STATE OF MAINE  
DEPARTMENT OF TRANSPORTATION  
16 STATE HOUSE STATION  
AUGUSTA, MAINE 04333-0016

January 23, 2026  
Subject: New Ferry Terminal  
parking lot and pedestrian access  
improvements  
State WIN: 026568.00  
Location: **Lincolnvile**  
**Amendment No. 1**

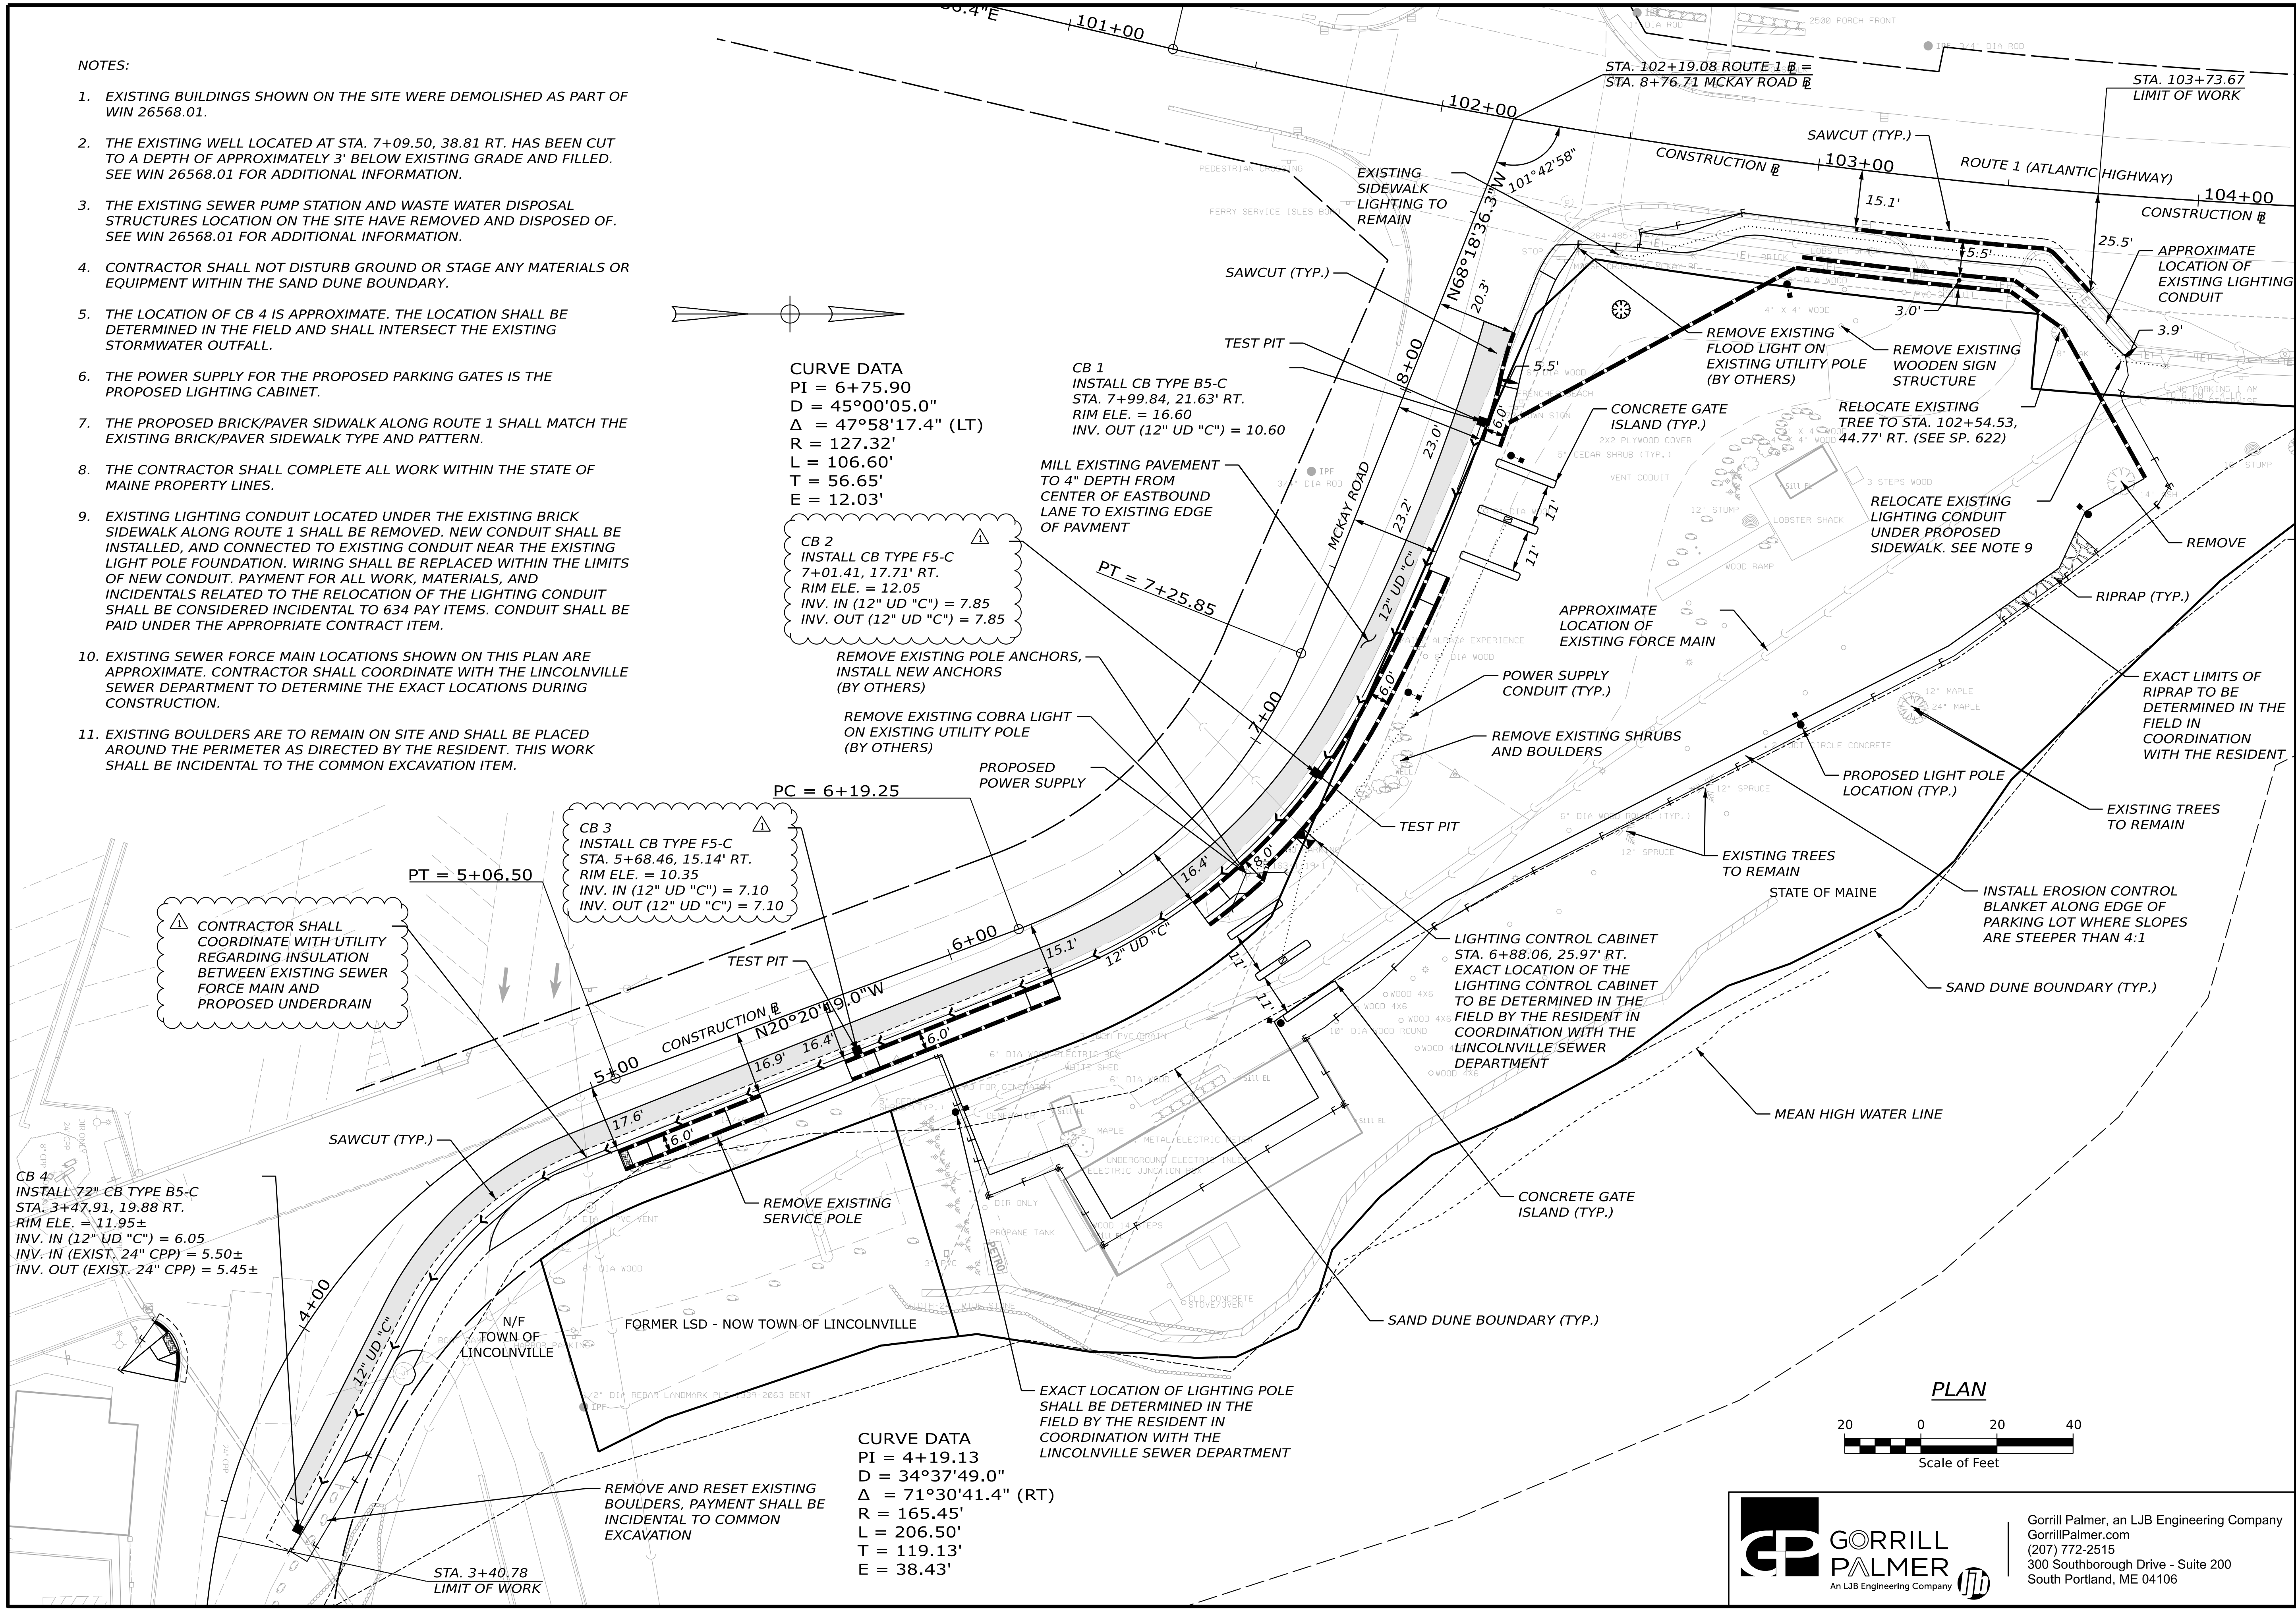
**Question:** In the area near STA 5+00 and 6+25 RT there will be silt fence installed. There are no grades provided in the section, are we to assume that we are paving directly on top of existing ground? Note 4 on Sheet 7 of 11 says no disturbance shall occur within the sand dune boundary.

**Question:** CB 2 and CB 3 do not line up with the dimensions provided on the plans, will these catch basins be altered or changed to an F basin?

Correct, the only disturbance within the sand dune limits that is allowed is in the areas of existing gravel, pavement or former building footprint as noted.

**Response:** Yes. Please **DELETE** plan sheets 5 and 7 and the Schedule of Items in the contract book and **REPLACE** them with the attached revised plan sheets 5, 7 and Schedule of Items.

**CB 2**  
 INSTALL CB TYPE F5-C  
 STA. 7+01.41, 17.71' RT.  
 RIM ELE. = 12.05  
 INV. IN (12" UD "C") = 7.85  
 INV. OUT (12" UD "C") = 7.85

**CB 3**  
 INSTALL CB TYPE F5-C  
 STA. 5+68.46, 15.14' RT.  
 RIM ELE. = 10.35  
 INV. IN (12" UD "C") = 7.10  
 INV. OUT (12" UD "C") = 7.10
